December 22, 2014

Re: Comments of the NSPS Subpart DD Coalition on EPA's Proposal of New Source Performance Standards for Grain Elevators, 79 Fed. Reg. 39242 (July 9, 2014)

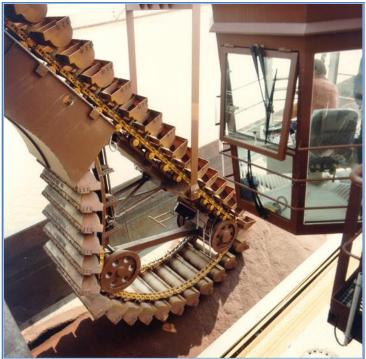
Under Subpart DD, EPA proposes to "clarify" section 302(d)(1) – the technology-based standard for barge and ship unloading – by adding the following statement: "Where aspiration of the casing provides dust control at the *boot of the conveyor* and a receiving hopper is not used, the unloading leg must be enclosed from the top to the center line of the bottom pulley and ventilation to a control device must be maintained on both sides of the leg." 79 Fed, Reg. at 39263 col. 2 (emphasis added). EPA explained: "Current § 60.302(d)(1) requires that the unloading leg be enclosed from the top, *including the receiving hopper*, to the center line of the bottom pulley. However, not all barge and ship unloading stations currently use a hopper. More recently, new technologies have been developed such that a hopper is not required." *Id.* at 39258 cols. 2-3 (emphasis added).

The Coalition understands EPA's explanation to be referring to the distinction between a vertical marine leg (*i.e.*, the unloading leg), which brings the grain out of the barge or ship, and a horizontal conveyor, which receives the grain directly from the vertical marine leg, without the intermediate use of a receiving hopper. Within the industry, the term "boot" is commonly understood to refer to the bottom of a vertical marine leg (*i.e.*, the unloading leg). In contrast, the term "tail" is commonly understood to refer to the receiving end of a horizontal conveyor. Thus, in barge/ship unloading, the unloading leg (*i.e.*, the vertical marine leg) in some applications discharges directly onto the "tail" of a horizontal conveyor.

EPA contends that the addition of that statement is merely a clarification of EPA's original intent in 1978. *See* 79 Fed. Reg. at 39244 col. 1, 39247 col. 3, and 39257 col. 3. It therefore proposes to apply the clarification "retrospectively". 79 Fed. Reg. at 39248 col. 3.

The Coalition disagrees with EPA's premise. The text of current Subpart DD clearly shows that EPA in 1978 had in mind only the combination of vertical marine leg and receiving hopper. Indeed, EPA acknowledges as much in its explanation (see quote above) when it refers to certain "new technologies", apparently including the combination of vertical marine leg and horizontal conveyor (without benefit of receiving hopper). EPA cannot say, therefore, that it intended to regulate the latter by means of the still-extant, 1978 version of Subpart DD. Consequently, the proposed clarification is actually an attempt to impose a new requirement, one that EPA may not apply retrospectively. The Coalition asks that EPA affirm that Subpart DD never governed the marine leg/horizontal conveyor combination and delete the clarification.

Figure 1. Simplified Schematic of Grain Column Dryer

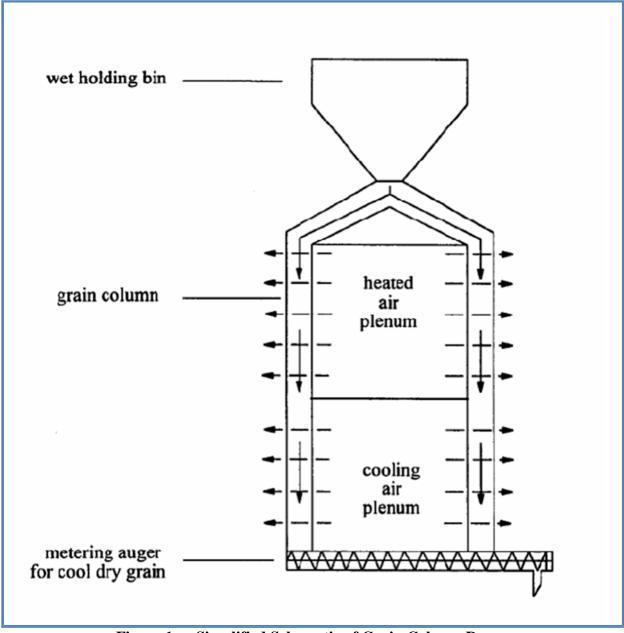
Subpart DD regulates emissions from certain column dryers. Figure 1 is a simplified crosssection sketch of a column dryer. In this type of dryer, wet grain is fed to the dryer at the top and flows by gravity through a packed column to the bottom of the dryer. Heated air is introduced on the inside of the columns and flows out through the grain to the atmosphere. The grain columns are contained by parallel walls constructed of perforated plates or wire mesh screens, depending on the application. Air moving through the grain columns dries the grain but also can entrain particulate matter, which may be emitted to the atmosphere.

Subpart DD only regulates emissions from certain types of column dryers. The rule defines a column dryer to be "any equipment used to reduce the moisture content of grain in which the grain flows from the top to the bottom in one or more continuous packed columns between **two perforated metal sheets**."[emphasis added] Thus, column dryers that contain the grain column between walls made of something other than perforated metal sheets (e.g., woven wire screens) are not considered column dryers for purposes of Subpart DD.

Under Subpart DD, any "column dryer" with a column plate perforation exceeding 2.4 mm diameter (ca. 0.094 inch) must meet a 0 percent opacity standard. Otherwise, Subpart DD contains no specific emission limits or other requirements for column dryers. The standard was established in this way because, during the 1977-1978 rulemaking process, EPA concluded that add-on controls for column dryers were not cost effective.<sup>1</sup> The structure of the rule language is such that meeting a design standard (e.g., a dryer having column plate perforations less than or equal to 2.4 mm in diameter) effectively exempts regulated column dryers from the 0 percent opacity standard.

Figure 2. Woven Wire and Perforated Plate Materials

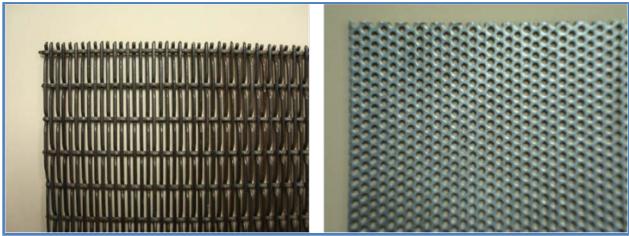
At the time the column dryer standard was developed, there may have been relatively few dryers that employed wire screens as walls to contain the grain columns in the dryer.<sup>2</sup> Wire screen walls are preferred for rice drying because they offer greater durability, result in less kernel damage, and provide for more efficient dryer operation. Figure 2 contains photographs of the two types of column dryer walls.
